CODY / ZEIGLER SUBDIVISION

APPLICATION NUMBER 6 DATE April 20, 2006
APPLICANT Cody/ Zeigler Subdivision
REQUEST Subdivision

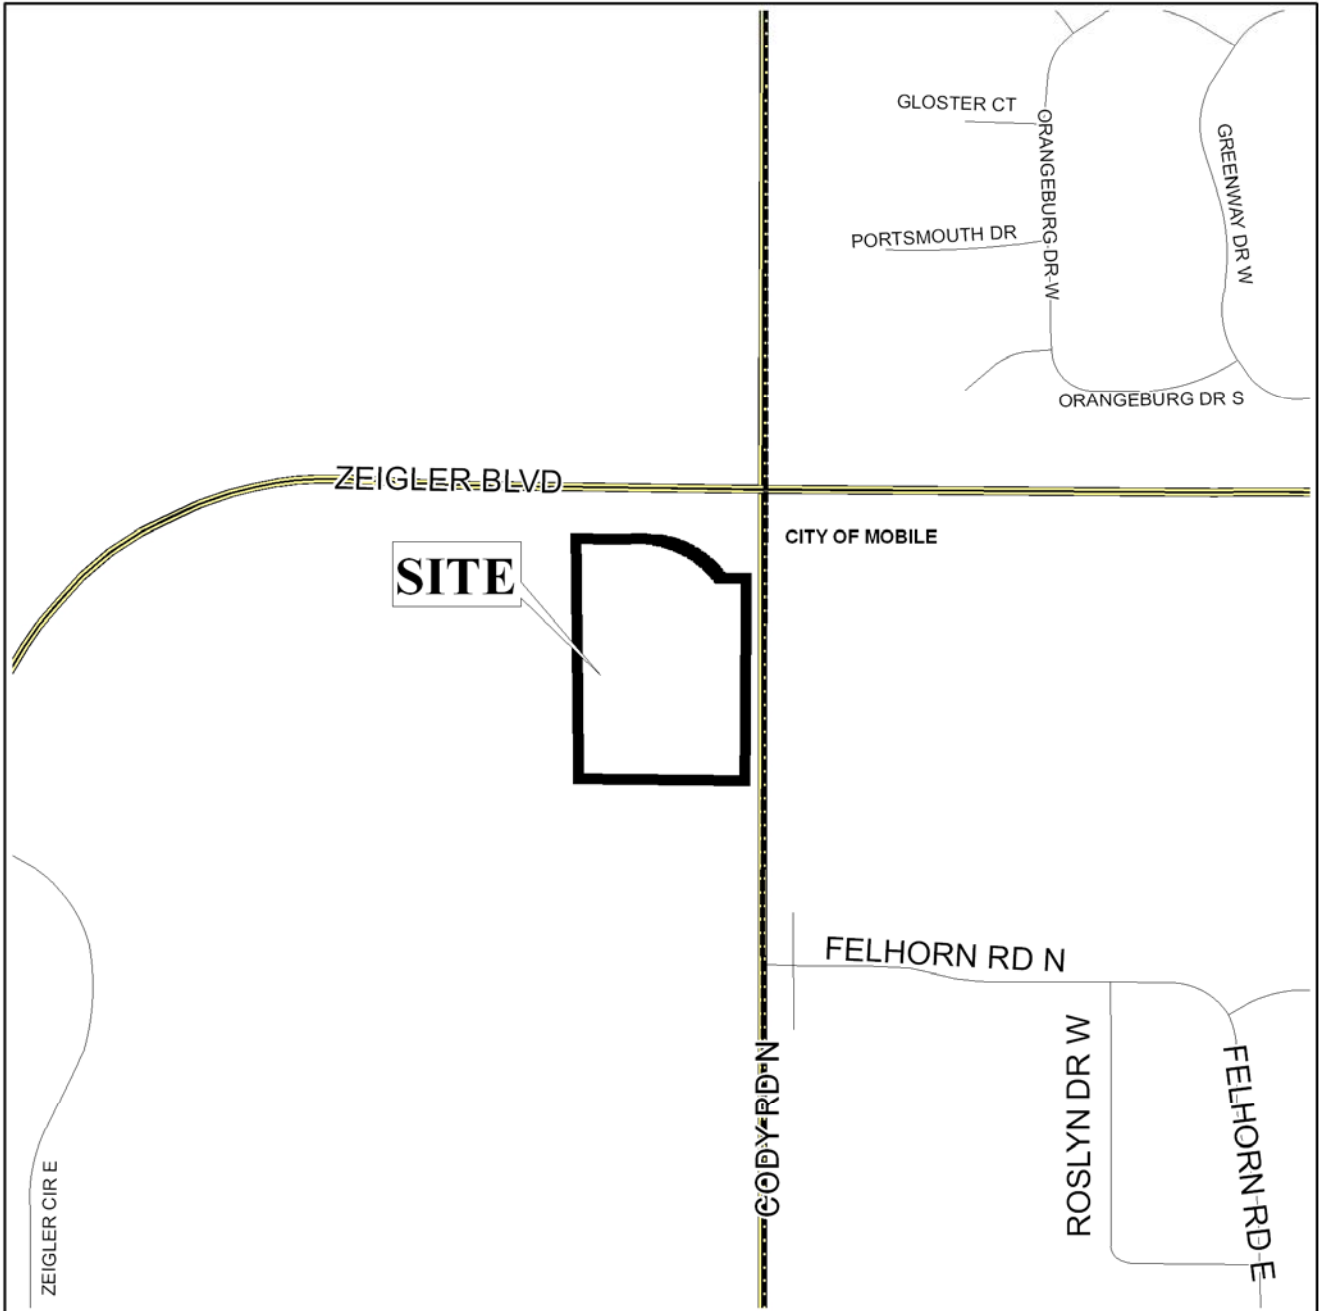
Cody Road North and Zeigler Boulevard are proposed major streets. The preliminary plat indicates that Cody Road's existing right-of-way is 80 feet, however, the Major Street Plan requires that the right-of-way be 100 feet. Therefore, the dedication of right-of-way sufficient to provide 50-feet as measured from the centerline of Cody Road, and to provide a smooth transition to the right-of-way of Zeigler Boulevard, should be required. The right-of-way of Zeigler Boulevard meets minimum requirements.

Because Cody Road North and Zeigler Boulevard are proposed major streets, access management is a concern. Lot A, with frontage on both roads, should be limited to one curb-cut onto each road. Lot B, which fronts onto Zeigler Boulevard, should be limited to one curb-cut due to the frontage being less than 200 feet. Lot C, with 360 feet of frontage on Zeigler Boulevard, should be limited to two curb-cuts. The size, design and location of all curb-cuts must be approved by the Mobile County Engineering Department.

The 25-foot minimum building setback line, required in Section V.D.9., is not shown for the subdivision, but would be required on the Final Plat, if approved.

Map data from the National Wetlands Inventory indicates that isolated wetlands may occur on or near the site. The presence of wetlands indicate that the area may be environmentally sensitive; therefore, the approval of all applicable federal, state and local agencies would be required prior to the issuance of any permits or land disturbance activities.

This site is located in Mobile County, thus a note should be placed on the Final Plat stating that any lots which are developed commercially and adjoin residentially developed property must provide a buffer, in compliance with Section V.A.7. of the Subdivision Regulations.

Finally, the road names on the vicinity map should be checked for spelling.

The plat is recommended for Tentative Approval, subject to the following conditions: 1) the dedication of right-of-way sufficient to provide 50-feet as measured from the centerline of Cody Road, and a smooth transition to the Zeigler Boulevard right-of-way; 2) placement of a note on the Final Plat stating that Lot A is limited to one curb-cut onto Cody Road North and one curb-cut onto Zeigler Boulevard, Lot B is limited to one curb-cut onto Zeigler Boulevard, and Lot C is limited to two curb-cuts onto Cody Road North, with the size, design and location of all curb-

cuts to be approved by the Mobile County Engineering Department; 3) depiction of the 25-foot minimum building setback line; 4) the approval of all applicable federal, state and local agencies, if necessary for wetlands, prior to the issuance of any permits or land disturbance activities; 5) placement of a note on the Final Plat stating that any lots which are developed commercially and adjoin residentially developed property must provide a buffer, in compliance with Section V.A.7. of the Subdivision Regulations; and 6) correction of any road name misspellings on the Vicinity Map.
